Memorandum

To: Planning Commission
From: Thomas Dansie, Director of Community Development
Date: **October 16, 2020**
Re: **October 21, 2020 Planning Commission Meeting**
Design / Development Review Modification – Transient Lodging Cabin Development, 1423 Zion Park Boulevard – Travis Barney

To: Planning Commission
From: Thomas Dansie, Director of Community Development
Date: October 16, 2020
Re: October 21, 2020 Planning Commission Meeting
 Design / Development Modification – Parking Area on Parcel S-56, Kurtis Maxwell

To: Planning Commission
From: Thomas Dansie, Director of Community Development
Date: October 16, 2020
Re: **October 21, 2020 Planning Commission Meeting**
Zone Change Proposal: PU Zone Change on Multiple Properties

GRADING PLAN & LANDSCAPE PLAN
 FOR
BARNEY CABINS
 FOR
TRAVIS & AMY BARNEY
 LOCATED IN THE NE 1/4 SEC 21, T4S, R10W, S188M
 SPRINGDALE, UTAH

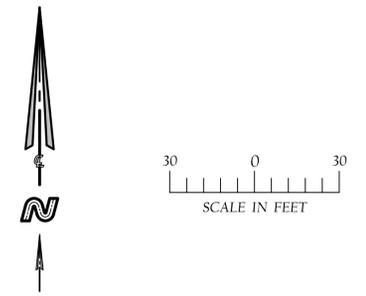
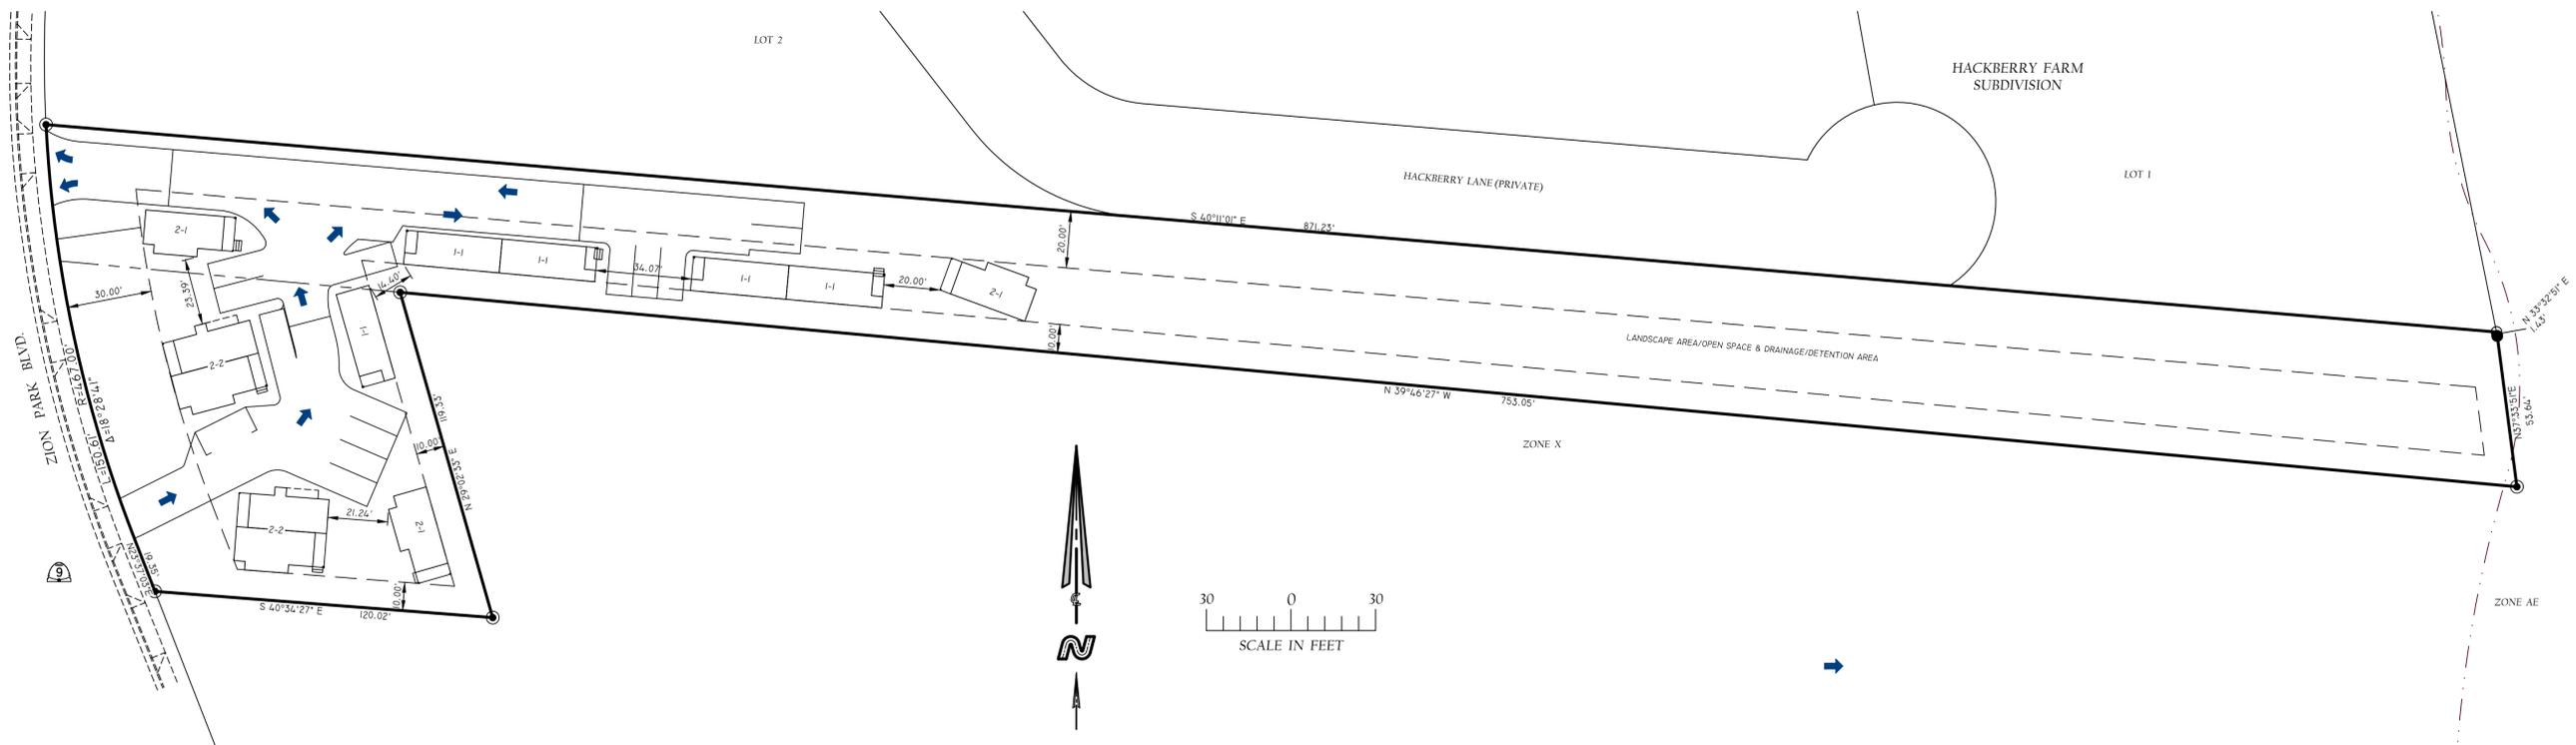
- Standard: Minimum of 60% of property must be landscaped (34,500sf on subject property), with tree and shrubs from plant list in quantities dictated by 10-18-4 (35 trees, 140 shrubs)
- Proposal: Landscape plan shows 72% of property in landscape with 24 trees and approximately 80 shrubs.
- Comment: The total amount of landscape on the property is in compliance. However, the landscape plan should be revised to show the required number of trees and shrubs, and ensure the trees and shrubs are selected from the approved plat list. Staff recommends a condition of approval requiring the revised landscape plan.

- Design standards: Chapter 10-16 of the Town Code contains guidelines for the design of new structures in the Town. The Commission may wish to review these standards and determine whether or not the proposed designs are consistent with the standards.
- Lot combination: The project is proposed on two separate parcels of property. To avoid issues with setbacks and landscape requirements on the individual parcels, the lots must be combined into one large parcel.
- Storm water runoff: The project will be required to submit a storm water management plan. The proposal includes storm water detention on the rear of the property. Storm water calculations must be included to verify the sizing of the detention areas.

- 1. The applicant must combine parcels S-74 and S-80 into a single parcel. The Town will not issue a building permit for the project until the lots have been combined.*
- 2. The applicant must submit a revised landscape plan showing the total number of required trees (35) and shrubs (140). The Town will not issue a building permit for the project until the revised landscape plan has been submitted.*
- 3. The applicant must provide additional detail on the proposed recessed can light fixtures, specifically: the color temperature of the light source, the number of lumens, and details regarding the 2" recess on the light source. The Town will not issue a building permit for the project until the revised lighting plan has been submitted.*

PROPOSED PARKING LAYOUT
 SPRINGDALE PARKING LOT
 FOR
 RALLYSTOP/ JENKINS OIL
 951 WINDERLAND LN, SPRINGDALE, UT 84767

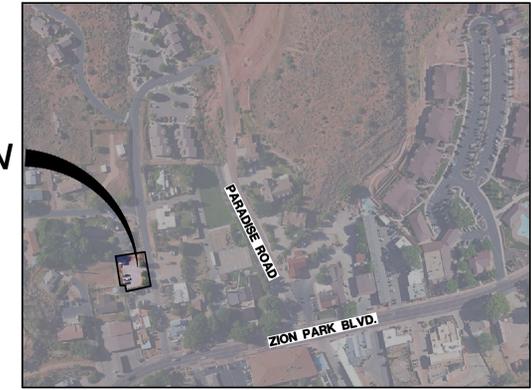
Standard	Requirement	Proposal	Comments
<i>Lot Area</i>	The minimum lot size is 0.25 acres.	The subject lot is 9,630 square feet, 0.22 acres.	The property does not comply with minimum size requirements. However, the lot was created prior to 1992. Lots created prior to 1992 are not subject to lot size requirements (see section 10-11A-4).
<i>Setbacks</i>	See section 10-11A-6	Front setback is 15 feet, side and rear is 10 feet.	In compliance.
<i>Building Size</i>	Maximum allowed building size is 8,500	No buildings are proposed.	In compliance.

In addition to the items reviewed above, the parking lot must meet the standards for construction and design on parking areas contained in Chapter 10-23 of the Town Code. The site plan contains notes demonstrating compliance with these standards.
